PIC16F88X Family Silicon Errata and Data Sheet Clarification

The PIC16F88X family devices that you have received conform functionally to the current Device Data Sheet (DS41291G), except for the anomalies described in this document.

The following typographic corrections and clarifications are to be noted for the latest version of the device data sheet (DS41291G):

FIGURE 1: SCK PULSE VARIATION USING TIMER2/2

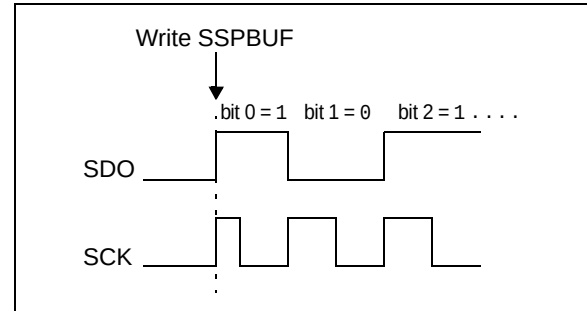
When the SPI is using Timer2/2 as the clock source, a shorter than expected SCK pulse may occur on the first bit of the transmitted/received data (Figure 1).

To avoid producing the short pulse, turn off Timer2 and clear the TMR2 register, load SSPBUF with the data to transmit and then turn Timer2 back on. Refer to Example 1 for sample code.

FIGURE 3: ACTUAL (INCORRECT) OPERATION WITH CLOCK STRETCHING – EXAMPLE 1

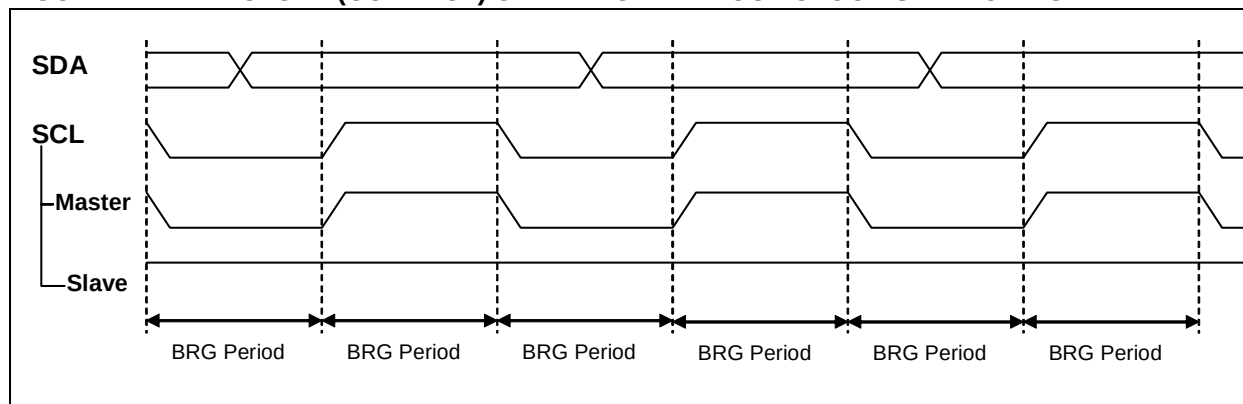
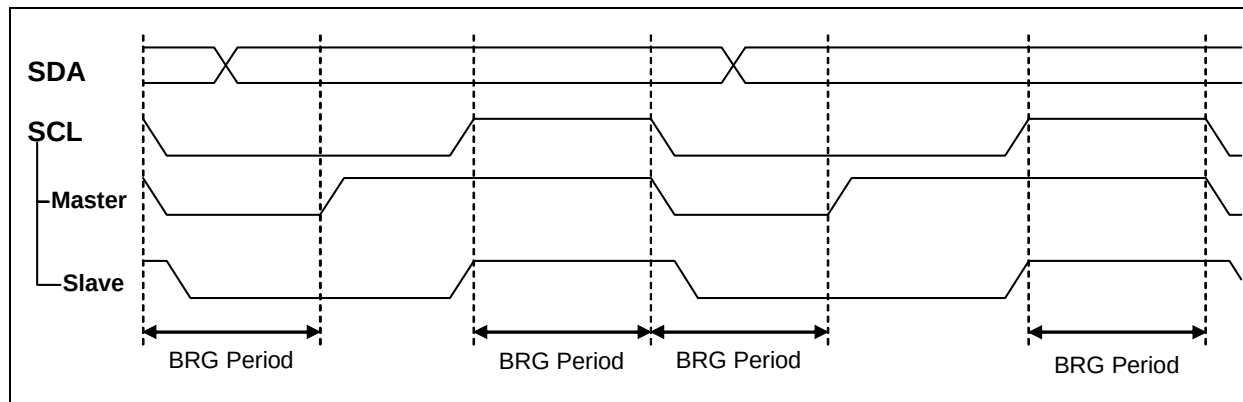
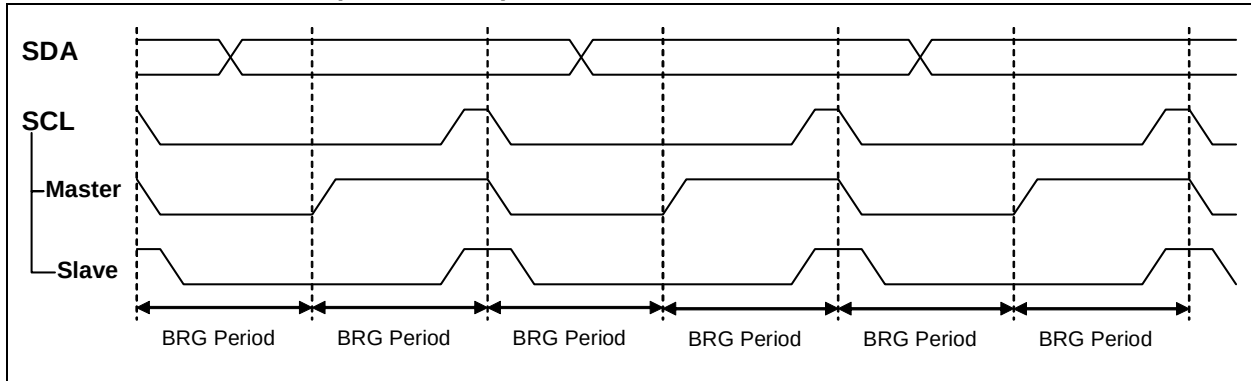
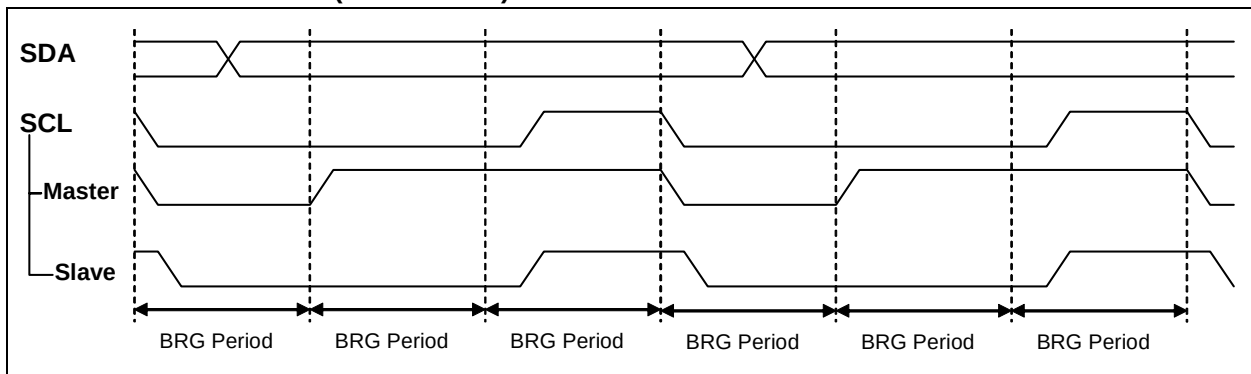
When the MSSP is I²C™ Master mode with a slave device stretching the clock, the clock generation does not function as described in the data sheet.

When a slave device is performing clock stretching by pulling the SCL line low, the master device should continuously sample the SCL line to determine when all slaves have released SCL. When SCL is released, the master device should wait one BRG period to ensure a constant SCL high time.

The current implementation does not ensure accurate SCL high time. During clock stretch, the MSSP device will erroneously continue running the BRG counter. At the end of the clock stretch, the BRG counter continues to count down for the

remainder of the BRG period, and then the MSSP device will immediately resume transmitting the data.

Figure 3 and Figure 4 illustrate an actual I²C transmission in which the slave has stretched the clock period by holding the SCL line low. Note that the high time of the SCL signal has shortened from the expected time.

Set the communication speed to match the slowest device on the bus. This ensures that no slave device will perform clock stretching.

It is possible to dynamically adjust the communication speed to match the device being addressed by modifying the BRG register. However, the behavior of slower slave devices must be understood and speed adjustments made such that no slave performs clock stretching.
